## 4.0L ENGINE BELT SQUEAL OR CHIRP NOISE ON COLD STARTUP

TSB 09-7-7

2009 Mustang  
2007-2008 Explorer Sport Trac, Explorer

2007-2008 Mountaineer

Figure 1 - Article 09-7-7

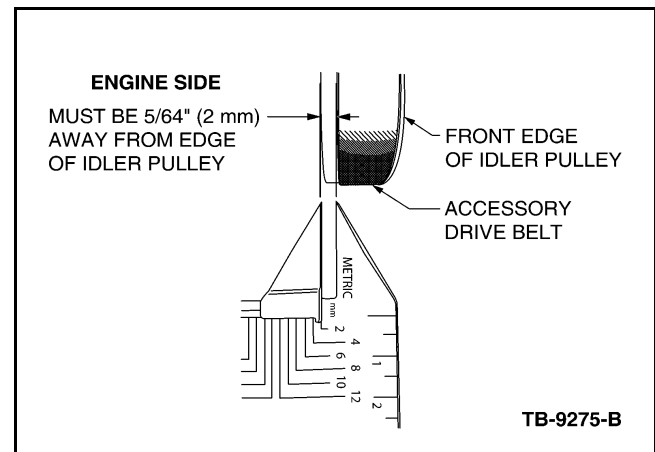
1. Visually inspect all related FEAD components for damage and or abnormal wear. Reference the online Work Shop Manual (WSM), Section 303-05. If no concerns found, proceed to Step 2.
2. Inspect for FEAD belt clearance on the idler pulley. A properly aligned belt will have an approximate  $3/32$ " (2 mm) space behind the belt on the idler pulley. (Figure 1)
3. Verify the generator bracket and idler pulley are properly seated and torqued to specification. Reference the online (WSM), Section 303-05.
  - a. If there is not an approximate  $3/32$ " (2 mm) gap, proceed with Step 3.
  - b. If there is an approximate  $3/32$ " (2 mm) gap, proceed with Step 5.
4. Replace the generator bracket with updated bracket. Reference online (WSM), Section 303-01. Proceed to Step 5.

5. Replace the accessory drive belt with the updated belt part number. Reference online (WSM), Section 303-05.
